Appendix II

Confirmatory Debris Generation Analyses

Figure II-1. Comparison of Jet Isobar Volumes

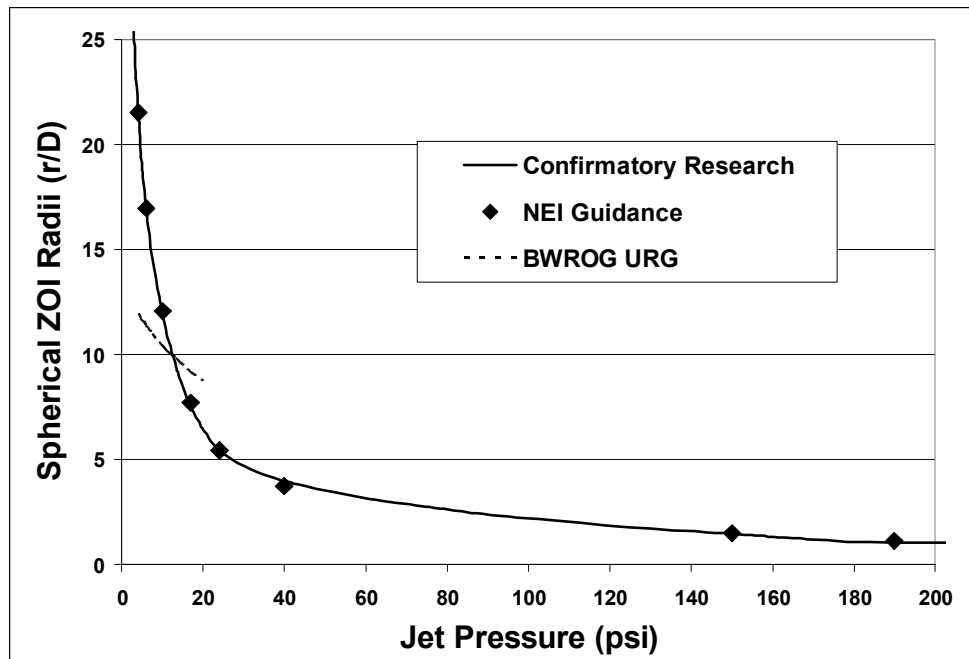
As shown, at the lower jet pressures, the pressure isobar volumes are much larger for the PWR two-phase LOCA jet than for the BWR steam jet. A principal reason for this difference is the higher energy associated with the higher pressure of a PWR reactor coolant system (RCS) than with a BWR RCS; however, another consideration is the accuracy of the ANSI/ANS-58.2-1988 standard at the lower pressures. For example, the validity of the assumption in the ANSI/ANS-58.2-1988 standard that the jet expands at a

half angle of 10 degrees once the jet expansion has reached the asymptotic plane becomes more important at the lower expansion pressures. The accuracy of the debris volumes of insulations that damage significantly at the lower jet pressures is subject to the accuracy of this assumption. Note that the confirmatory research and NEI-recommended-equivalent spherical ZOI radii are in good agreement.

Figure II-2. LDFG Damage Curve for Small Fine Debris

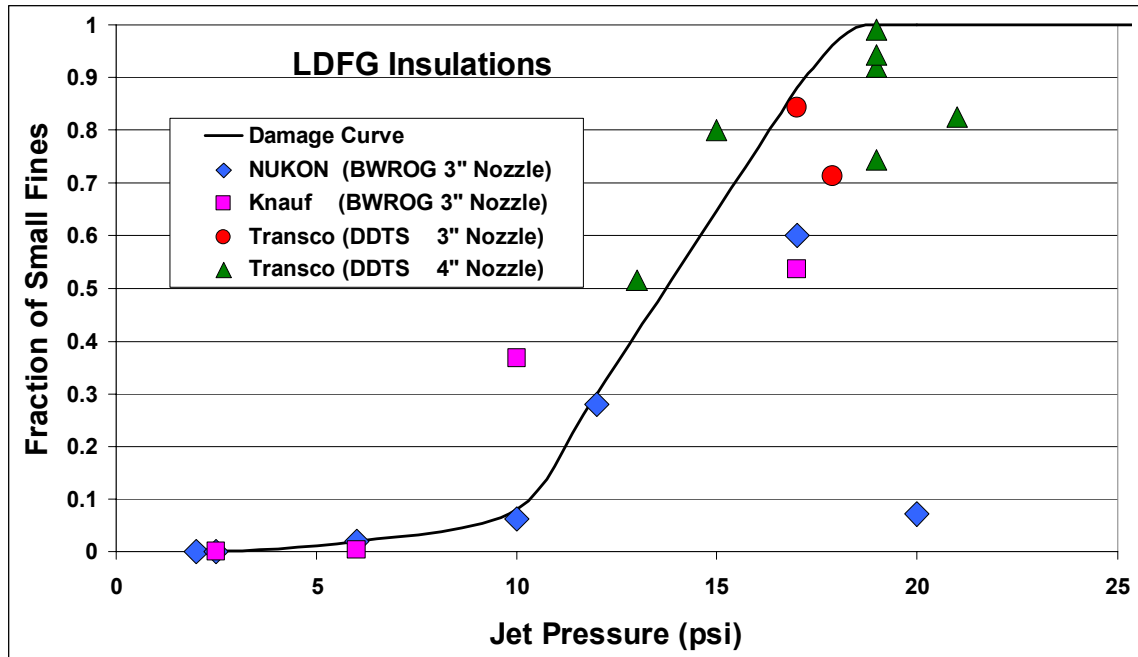
Figure II-2 plots the fractions for the small fines from the AJIT debris generation test data as a function of the jet centerline pressure for these three types of LDFG insulations. A curve drawn through the data represents the damage as a function of jet pressure for use in the damage integration over the ZOI. One set of seven data points was from tests (in the DDTS) that used a 4-in. nozzle, whereas the remainder used a 3-in. nozzle. The 4-in. nozzle data from the DDTS generally shows more damage than do the 3-in. nozzle tests. In general, the higher damage occurred because the larger diameter jet exposed more of the target insulation blanket to higher pressures. Note that the data were correlated by the estimated jet centerline pressure, but the pressure on the blanket decreased outward from the centerline. When the blanket was placed close to the jet, the ends of the blanket were hit with substantially less force of flow than the centerline for which the data were correlated. For example, the 3-in. nozzle data point for NUKON™ at a jet pressure of 20 psi damaged only approximately 7 percent of the insulation into small fine debris, whereas this pressure totally destroyed the TPI blankets in the 4-in. nozzle. Apparently, testing blanket destruction for insulations requiring a pressure higher than approximately 17 psi requires a jet nozzle larger than 3 in. For LDFG, any jet pressure larger than 17 psi will totally destroy the blanket into small fine debris, whereas the NEI guidance cited an OPG two-phase jet test with 52 percent of the insulation damaged into small fine debris as its basis of conservatism.

Another significant point of discussion is that the threshold of damage for LDFG insulation has been specified as 10 psi, where Figure II-2 clearly shows damage at jet pressures less than 10 psi. Apparently, neglecting the tail of the damage curve was considered acceptable for the BWR strainer resolution because of the lesser BWR jet volumes at lower pressures, as shown in Figure II-1. However, the much larger jet volumes below 10 psi for the Confirmatory Research/NEI Guidance PWR jet shown in Figure II-1 make the neglect of the tail less acceptable.

Figure II-3. Potential Volumes of Small Fine LDFG Debris

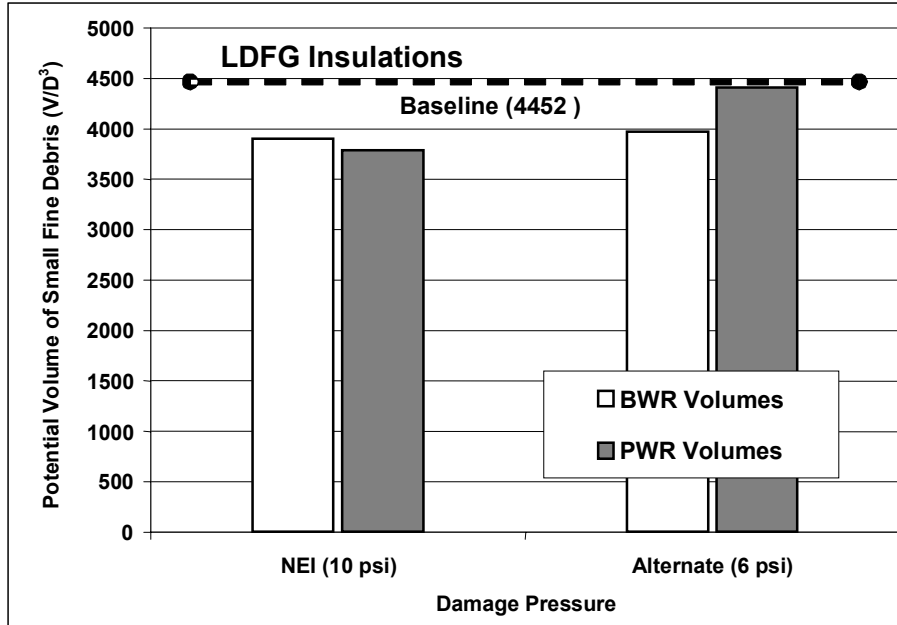
Table II-2 provides the results of debris-size distribution integration over the ZOI. A lower alternate damage pressure results in a larger equivalent spherical ZOI; however, a lesser fraction of the debris is damaged into small fine debris. The use of the alternate damage pressures over the NEI-recommended damage pressures for PWR analyses would result in approximately 16 percent more small fine debris. Figure II-3 compares the potential debris volumes and provides an estimate using the baseline guidance. The baseline estimate is simply 60 percent of $4\pi/3 (12.1/D)^3$. As shown, the baseline guidance appears to be conservative, but not overly so.

- A comparison of the NUKON™ results with the BWROG URG steam jet model illustrates that the neglect of the tails of the debris damage curve has a larger impact for PWRs than for BWRs (see Figure II-3).

Figure II-4. Temp-Mat Damage Curve for Small Fine Debris

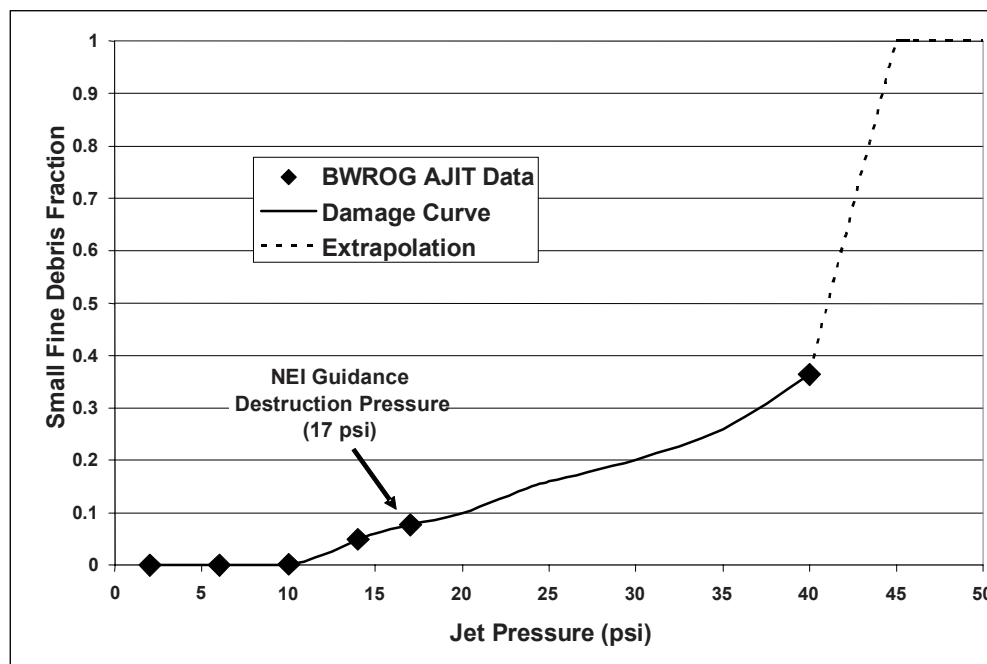
Figure II-4 shows the Temp-Mat insulation debris fractions for the small fine debris from the AJIT tests. This figure shows six data points for Temp-Mat, two of which represent tests where no significant damage was noted. The test with the maximum damage had approximately 36 percent of the insulation damaged into small fine debris, with the remainder of the insulation forming large-piece debris. Unfortunately, no tests were conducted with jet pressures high enough to complete the damage curve to total destruction into small fine debris, as was done for the LDFG insulations. Therefore, a conservative extrapolation of the data is required to perform the debris generation integration over the equivalent ZOI sphere. Figure II-4 shows the extrapolation used herein as a dashed line. Figure II-4 also illustrates the selection of the NEI-guidance damage pressure of 17 psi, where it is seen that significant small fine debris is generated at jet pressures below 17 psi.

Figure II-5. Potential Volumes of Small Fine Temp-Mat Debris

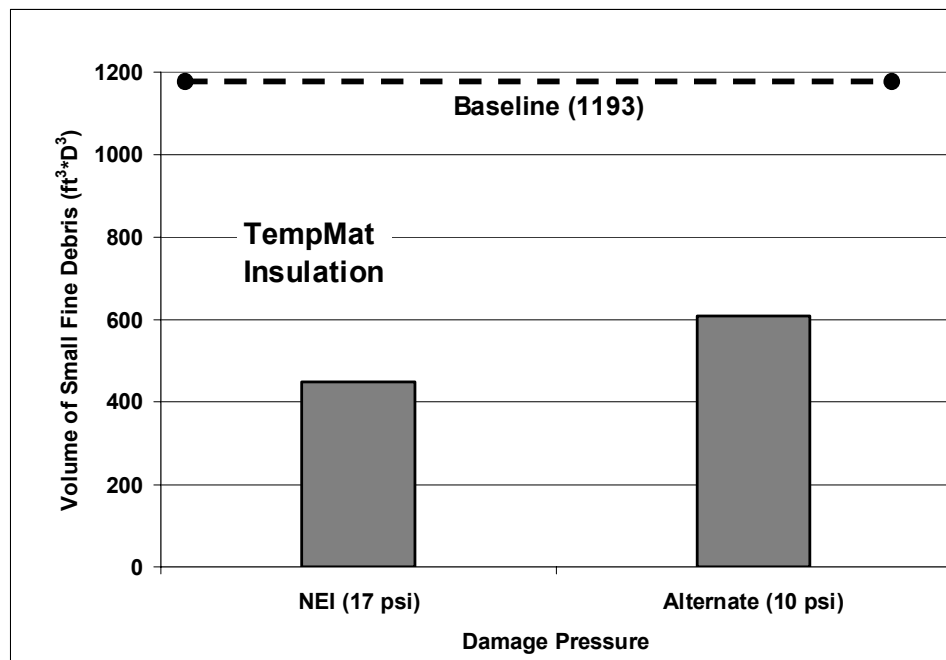
Table II-3 provides the results of the Temp-Mat debris-size distribution integration over the ZOI. Figure II-5 compares the potential debris volumes and provides an estimate using the baseline guidance (60 percent of $4\pi/3 (7.8/D)^3$). A lower alternate damage pressure results in a larger equivalent spherical ZOI; however, a lesser fraction of the debris is damaged into small fine debris. The use of the alternate damage pressures over the NEI-recommended damage pressures for PWR analyses would result in approximately 36 percent more estimated small fine debris. For Temp-Mat insulation, the baseline is conservative with respect to both the NEI-guidance damage pressure of 17 psi and the alternate pressure of 10 psi.

Figure II-6. K-Wool Damage Curve for Small Fine Debris

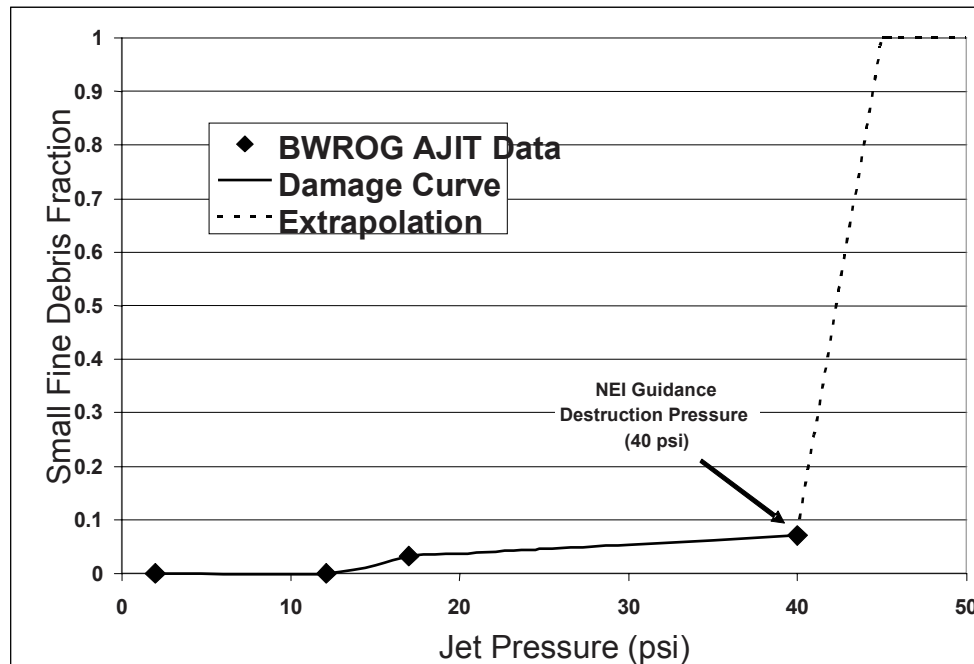
insulation debris fractions for the small fine debris from the AJIT tests. This figure shows only four data points for K-wool, two of which represent tests where no significant damage was noted. The test with the maximum damage had approximately 7.1 percent of the insulation damaged into small fine debris, with much of the remainder of the insulation still contained in the blanket cover and still attached to the target mount. As with the Temp-Mat data, the K-wool damage curve is incomplete because the highest jet pressure tested was that of the NEI-recommended damage pressure. To perform the debris generation integration over the equivalent ZOI sphere, the test data were conservatively extrapolated, as shown in Figure II-6.

Figure II-7. Potential Volumes of Small Fine K-Wool Debris

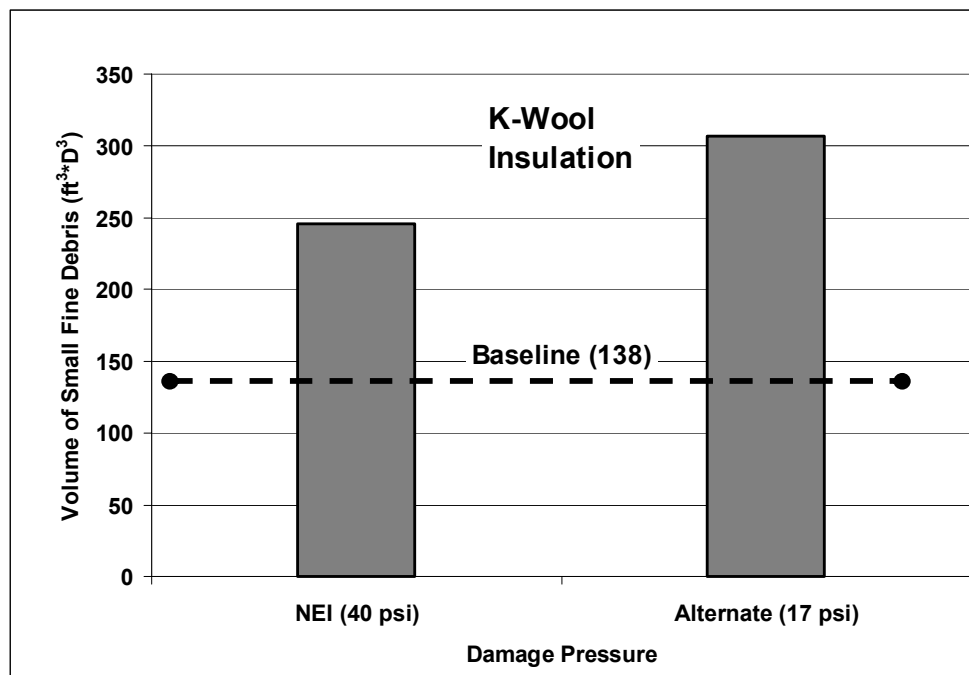
Table II-4 provides the results of the K-wool debris-size distribution integration over the ZOI. Figure II-7 compares the potential debris volumes and provides an estimate using the baseline guidance (60 percent of $4\pi/3 (3.8/D)^3$). The lack of debris generation data for a jet pressure higher than the NEI-recommended destruction pressure of 40 psi makes K-wool integration difficult. Therefore, to ensure conservative debris-size integration, it must be assumed that the insulation is completely destroyed at a pressure higher than 40 psi (i.e., the integration herein assumed to be 100 percent at 45 psi). However, this assumption may be overly conservative. For K-wool insulation, the baseline is not conservative with respect to either the NEI guidance damage pressure of 40 psi or the alternate pressure of 17 psi.

Figure II-8. Comparison of Fibrous Insulation Damage Curves

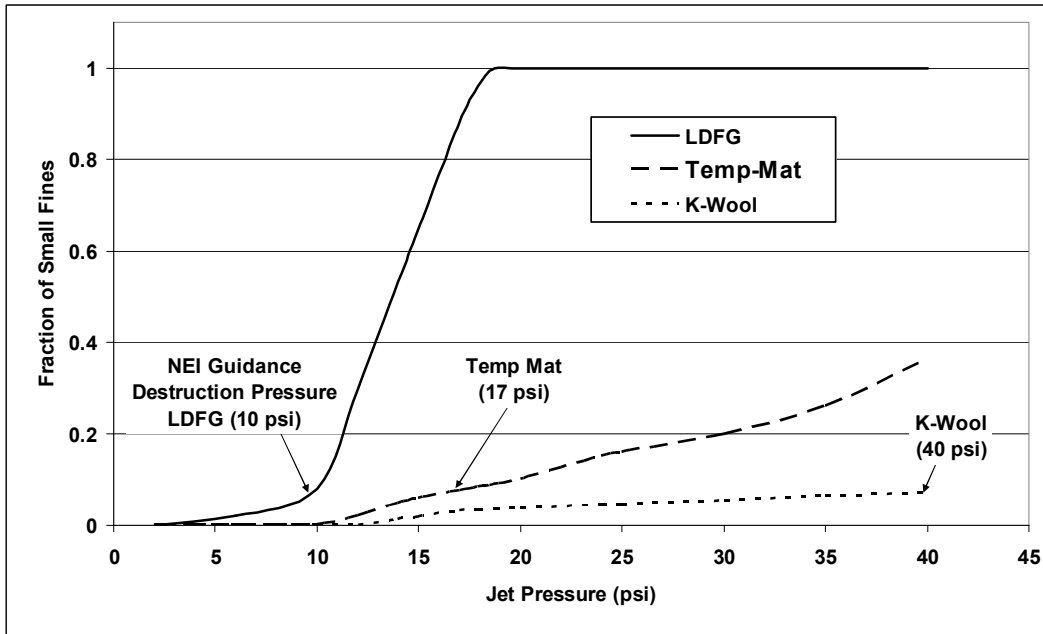
This damage curve comparison for LDFG, Temp-Mat, and K-wool does seem to support the concept that a higher destruction pressure results in the fractions of small fines becoming increasingly smaller as the destruction pressure increases. Certainly this is the case for Temp-Mat, where the baseline guidance is conservative relative to the integration herein and both the fractions of small fine debris and the potential debris volumes are smaller than the baseline guidance. Although this case is likely true for K-wool as well, it cannot be proven conclusively because of the complete lack of data beyond the NEI-recommended destruction pressure.

- The NEI guidance recommendation that adapts the debris-size distribution for NUKON™ to other types of fibrous insulation that have a destruction pressure higher than that of NUKON™ has been partially supported (see Figure II-8), although it cannot be conclusively ensured.

Figure II-9. TPI Stainless-Steel RMI Small-Fine-Debris Fractions

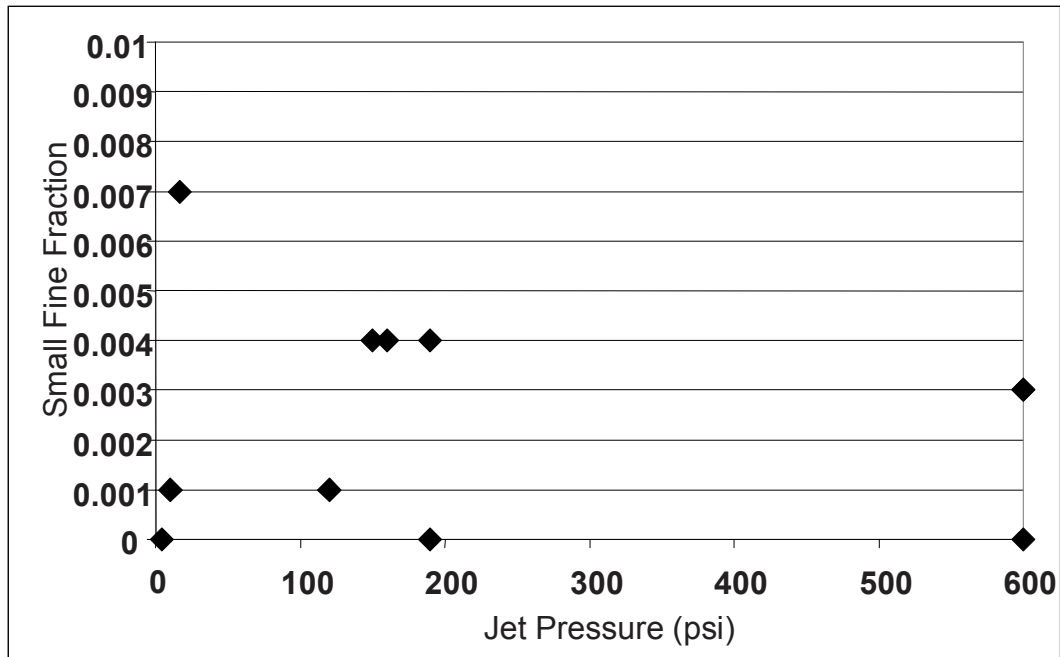
TPI manufactures stainless-steel and aluminum RMI insulation. The NEI guidance recommends a destruction pressure of 190 psi for the TPI RMI. The TPI cassettes tested included both aluminum and stainless-steel foils encased in stainless-steel sheaths secured with latches and strikes (no bands were used). Although the recommended destruction pressure is 190 psi, a small amount of fine debris was noted for jet pressures as low as 10 psi (Test 21-3). On the other hand, only small quantities of fine debris (i.e., less than 0.5 percent) were found for tests with jet pressures as high as 600 psi. Figure II-9 shows the debris generation fractions for TPI stainless-steel RMI small fine debris.

Table II-7 compares potential debris volumes when estimated using the NEI baseline guidance and when acknowledging debris generation at jet pressures as low as 10 psi. As stated above, to obtain actual volumes of debris, the potential volumes must be multiplied by the insulation concentration and again by D^3 . For the baseline estimate, the volume associated with a ZOI radius of $1.3/D$ is multiplied by 75 percent to obtain the baseline potential volume. For the alternate estimate, the ZOI volume out to a jet pressure of 10 psi was multiplied by 0.5 percent to obtain the alternate potential volumes. The application of the alternate pressure results in approximately three times as much small fine debris as using the baseline guidance. However, even these quantities are not very large compared with such insulations as LDFG.

Figure II-10. DPSC Mirror Damage Curve for Small Fine Debris

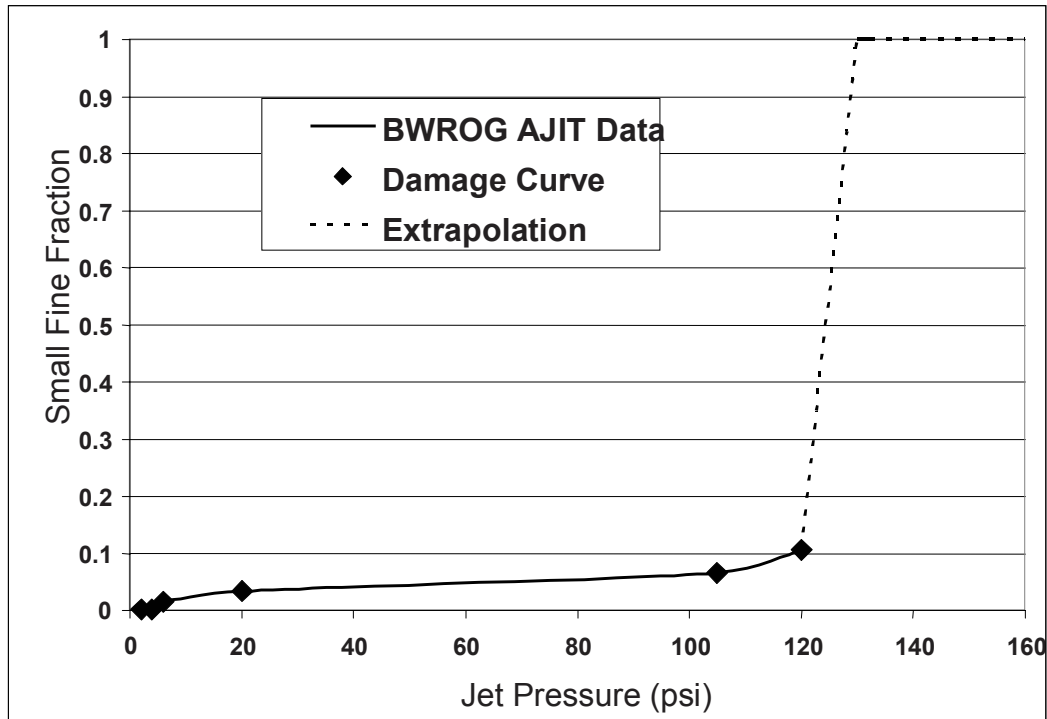
Figure II-10 shows the debris fractions for the small fine debris from the AJIT tests. In the figure, the small fine debris was correlated as pieces less than 6 in., although the NEI guidance specified RMI small fines as less than 4 in.; therefore, a small measure of conservatism was added to the comparison. Figure II-10 shows six data points for Mirror[®], with two of those tests generating very minor quantities of small fines. Note that with the lower pressure test, where the RMI cassette was exposed to a jet pressure of only 2 psi (AJIT Test 18-3), the cassette was still detached from the target mount, leaving two half cassettes on the chamber floor. The test with the largest quantity of small fine debris (AJIT Test 17-1) had only 10.6 percent of the foils turned into pieces less than 6 in., with the remaining foils becoming large-piece debris. The conservative extrapolation shown in Figure II-10 to complete the spherical ZOI debris fraction integration assumes complete destruction at a jet pressure of 130 psi. Note that in the single NRC-sponsored Mirror[®] debris generation test conducted at the KWU test facility, the test article was completely destroyed.

Table II-8 provides the results of the Mirror[®] debris-size distribution integration over the ZOI. The potential debris volume of $661/D^3$ is quite low compared with an estimate using the baseline guidance (i.e., 75 percent of $4\pi/3 (21.6/D)^3$) of $31660/D^3$. Although this insulation is damaged at jet pressures as low as 4 psi, a relatively small amount of small debris is formed at pressures less than approximately 120 psi, and when the debris damage data are applied to the larger ZOI radius of 21.6/D, only a small fraction of the insulation in that sphere becomes small fine debris. For DPSC Mirror[®] RMI insulation, the assumption in the NEI baseline guidance that 75 percent of the insulation within a 21.6/D ZOI sphere would become debris less than 4 in. in size (i.e., $31,660/D^3$) is overly conservative. However, the quantities of large-piece debris, including nearly intact cassettes, could be very large because even 2 psi can detach the cassettes, which could become very important in containments where the transport velocities are high enough to move this heavier debris significantly.

Figure II-12. Calcium Silicate Damage Curve for Small Fine Debris

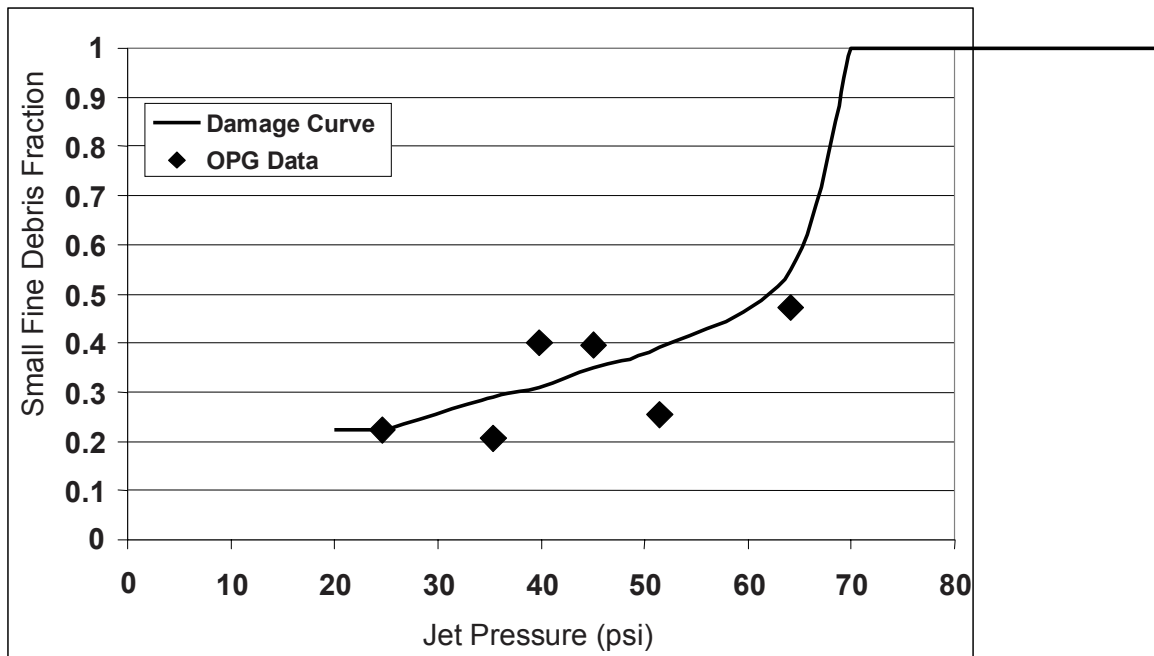
The damage curve shown in Figure II-12 was generated by summing all four debris categories in Figure II-11 to obtain the OPG debris fractions shown and then constructing a plausible curve through the data that was conservatively extrapolated at both ends. Table II-9 provides the results of the calcium silicate debris-size distribution integration over the ZOI. Figure II-13 compares the potential debris volumes and provides an estimate using the baseline guidance ($100 \text{ percent of } 4\pi/3 (5.45/D)^3$). A lower alternate damage pressure results in a larger equivalent spherical ZOI, but a lesser fraction of the debris is damaged into small fine debris. The use of the alternate damage pressures over the NEI-recommended damage pressures for PWR analyses would result in approximately 43 percent more estimated small fine debris. For calcium silicate insulation, the baseline is conservative with respect to both the NEI guidance damage pressure of 24 psi and the alternate pressure of 20 psi.
